Re: Proposed Orbital Launch Complex at Whalers Way (EPBC 2021/9013)

NCSSA comments on EPBC Act Draft Preliminary Documentation (Draft PD) for the Proposed Action of the Whalers Way Orbital Launch Complex (EPBC 2021/9013), dated December 2023

Figure 1: Plans for the Whalers Way Orbital Launch Complex as per Guidelines for the preparation of an Environmental Impact Statement: Whalers Way Orbital Launch Complex’ dated 23 July 2020

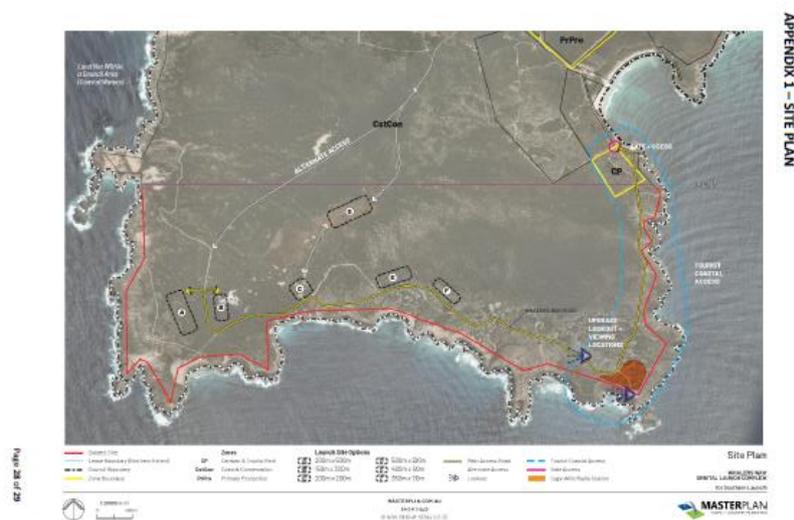
Following your flawed site selection process and the failed opportunity to avoid the damage you are proposing by avoiding a nature conservation area, you state repeatedly throughout the Draft PD that impact of your proposal has been reduced because “further consideration in the design process has reduced the size of the Disturbance Footprint from 70.58ha to 23.4ha” (for example, on page 111).

The NCCSA queries this claim since information on the ‘original’ design requiring 70.58ha of clearance is not presented. It may relate to the later stages of planned development of your Complex, i.e. stages that are planned for after this approval is received, if it is granted. A much bigger planned Complex appears in the ‘Guidelines for the preparation of an Environmental Impact Statement: Whalers Way Orbital Launch Complex’ dated 23 July 2020 (Figure 1).

Figure 2: Taken from page 81 of the Draft PD, the noise modelling predicts loud noise disturbance over significant distances from launches, should they be permitted from Whalers Way. Note that this modelling is for Site B, which will host smaller rockets than the planned Site A.

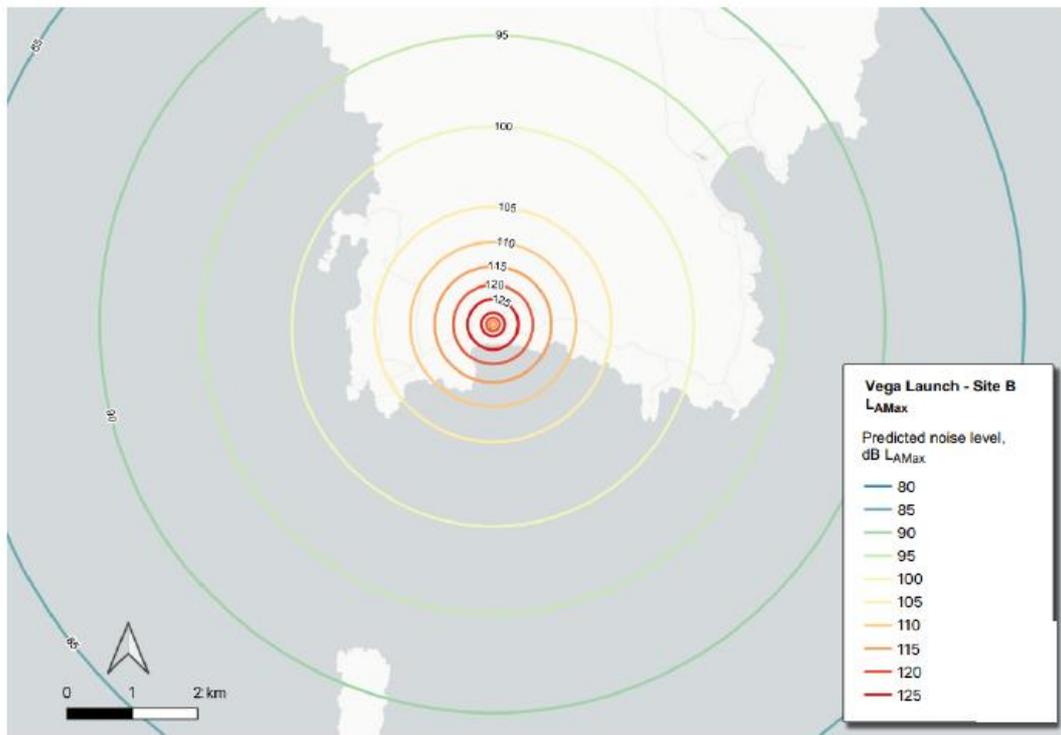
The NCCSA notes that the predicted airborne noise contours presented in the Draft PD suggest significant sound impacts from rocket launching over large distances (Figure 2).

The NCSSA notes that the calculations presented in the Draft PD are something of a “best case scenario” since they relate only to Site B, whereas larger rockets are planned for Site A, which is the launch pad closer to the highest number of Southern Emu-wren records. The analysis of likely noise impacts presented in Appendix E, using the Unweighted Sound Exposure Level (L_E) which was purportedly included to support wildlife assessments, suggests a much greater impact over many more kilometres for launches from the planned Site A, with sound of over 120 decibels extending virtually across the whole of Whalers Way during a launch event (Figure 3).

Figure 3: Taken from Appendix E, noise modelling using the Unweighted Sound Exposure Level (L_e) which was included to support wildlife assessments predicts significant exposure of over 120 dB for most of the Whalers Way site.

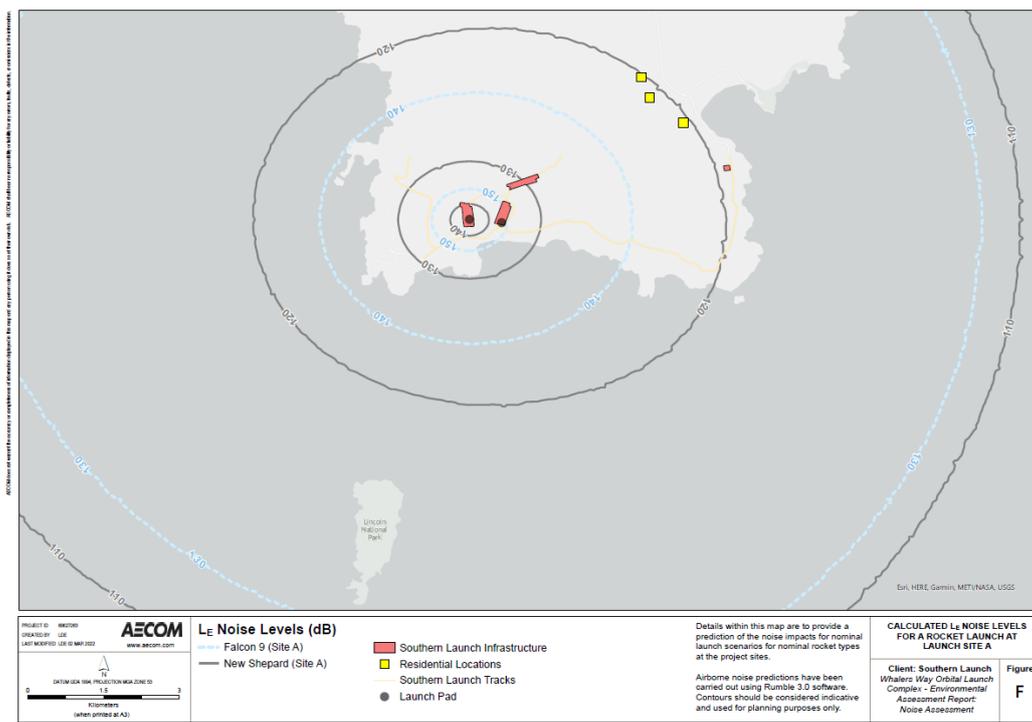
The NCSSA therefore does not agree with your statement that “taking into account the infrequency and short duration noise emission, the overall risk of significant or long-term adverse behavioural impacts is considered to be low”, on page 24 of Appendix K, as there is absolutely no evidence to support this assertion.
